### **GEOTECHNICAL INVESTIGATION AND PEER REVIEW**

**FINAL GEOTECHNICAL INVESTIGATION  
PROPOSED RESIDENTIAL DEVELOPMENT  
1008, 1016, AND 1028 CAROLAN AVENUE /  
935 ROLLINS ROAD  
BURLINGAME, CALIFORNIA**

## **RESPONSE TO PEER REVIEW**

**SUBJECT:** Response to Peer Review Comments

Figure 2

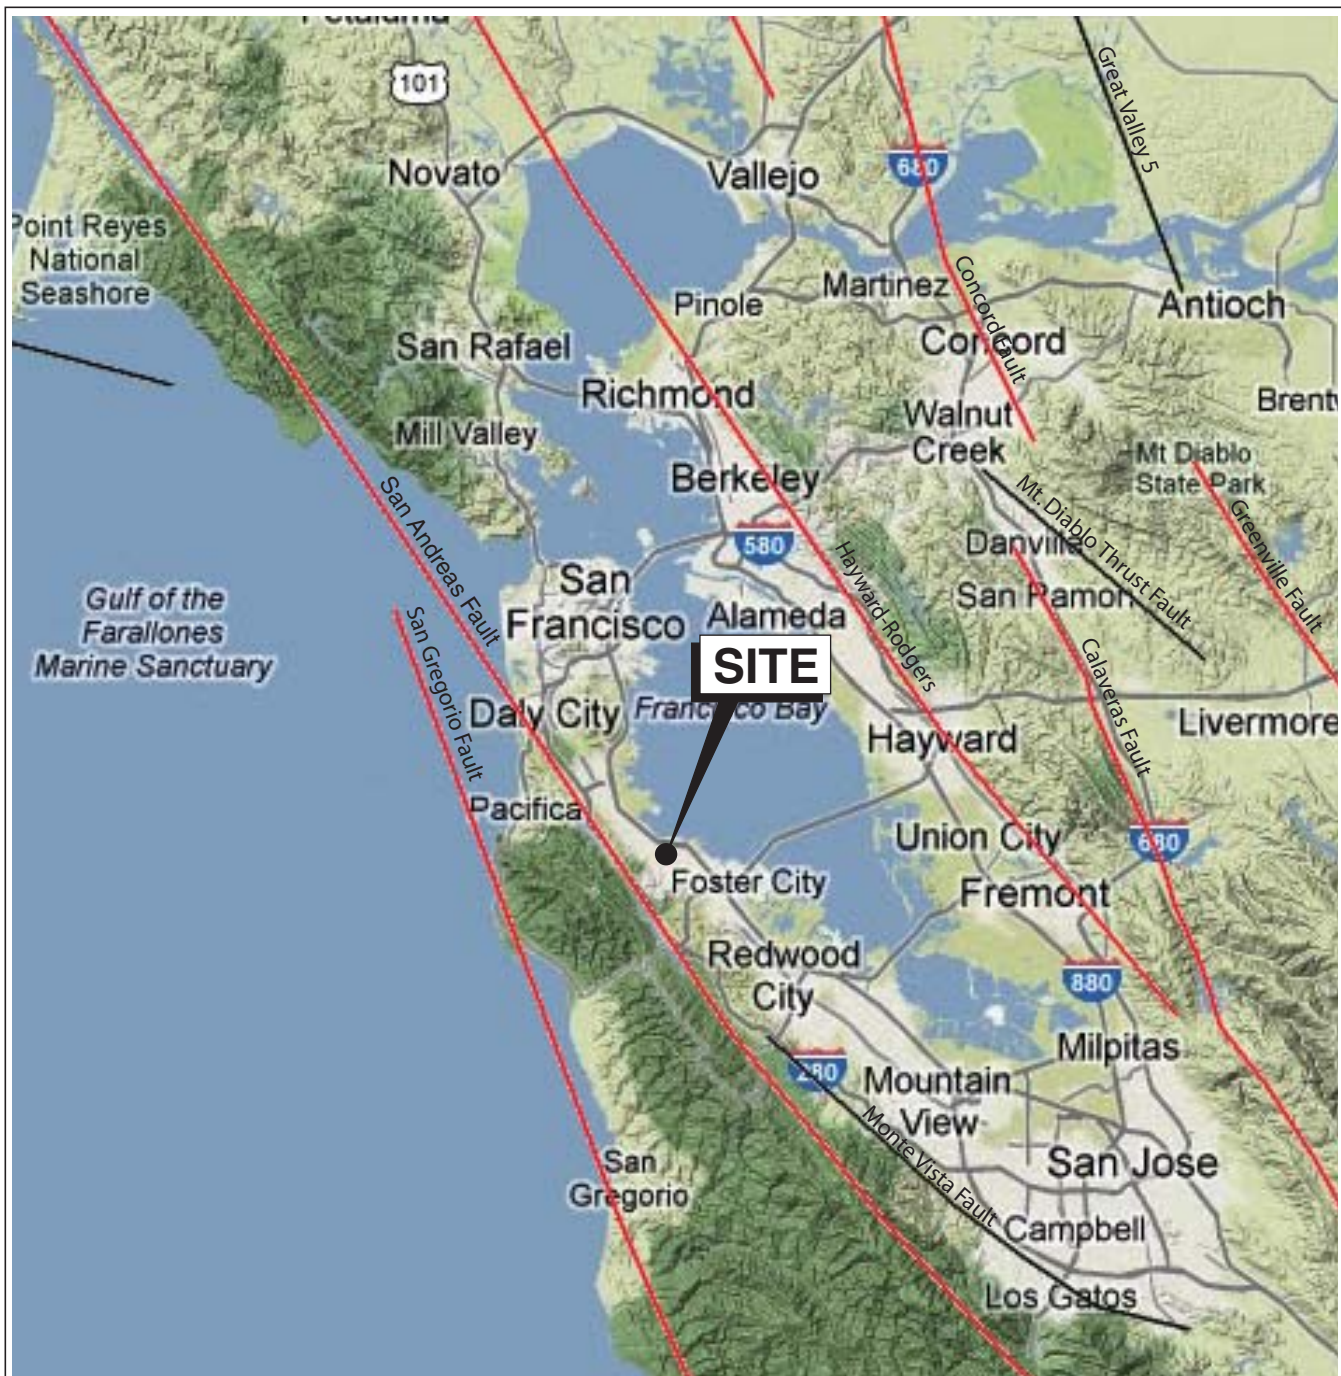
Comment #4: *“The consultant identifies the depth of undocumented fill encountered within the footprint of the proposed townhome buildings was up to about 5 feet below the existing grade (Boring B-4). The consultant’s recommendations to remove and replace 18 inches of soil below the bottom of footings does not address the full depth of undocumented fill encountered. The performance of undocumented fill under the townhomes may be difficult to predict if the undocumented fill is not removed and replaced as engineered fill in its entirety.”*

Response: Considering the current relative density of the fill, as indicated by the recorded CPT tip resistances and SPT blowcounts, the fact that the upper 18 inches of existing fill will be re-worked, the relatively lightweight building type (2-story, wood-framed), and the fact that the recommended foundations consist of stiffened P-T slabs designed to accommodate up to one inch of differential settlement over 30 feet (static plus seismic), we conclude the inherent uncertainties associated with the undocumented fill have been appropriately accounted for.

Figure 4

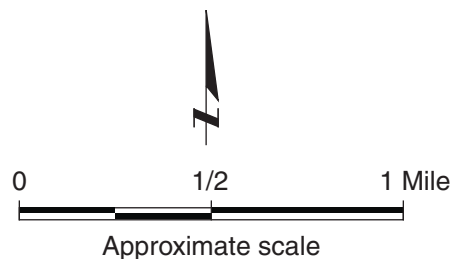
Comment #1: *"The site is mapped as being partially underlain by Bay Mud (Helley and Lajoie, 1979), identified as Marsh Deposits by the consultant. Rockridge recommends surcharging for the southern end of the townhomes. Further exploration prior to surcharging should be performed to determine the limits of the marsh deposits. The consultant may want to consider a site specific geologic map indicating areas underlain by the compressible organic clay deposits."*

Response: Despite the referenced geologic mapping, the results of our site-specific exploratory borings and CPTs do not indicate typical Young Bay Mud is present beneath the site. The isolated thin (2 to 3 feet thick) layer of weak, compressible marsh deposits was encountered in boring B-4 and CPT-4 in the southeast corner of the site, but not in CPT-7, approximately 250 feet northeast along the proposed townhome alignment. Rather than performing additional investigation to further characterize the lateral extents of these deposits, we recommended the entire townhome area from Carolan Avenue to about 250 feet northeast be surcharged during construction. Based on discussions with Summerhill Apartment Communities, we understand the proposed construction schedule can easily accommodate the proposed surcharge program and soil is readily available from the podium building excavation. Therefore, further investigation is not necessarily warranted from a geotechnical standpoint.
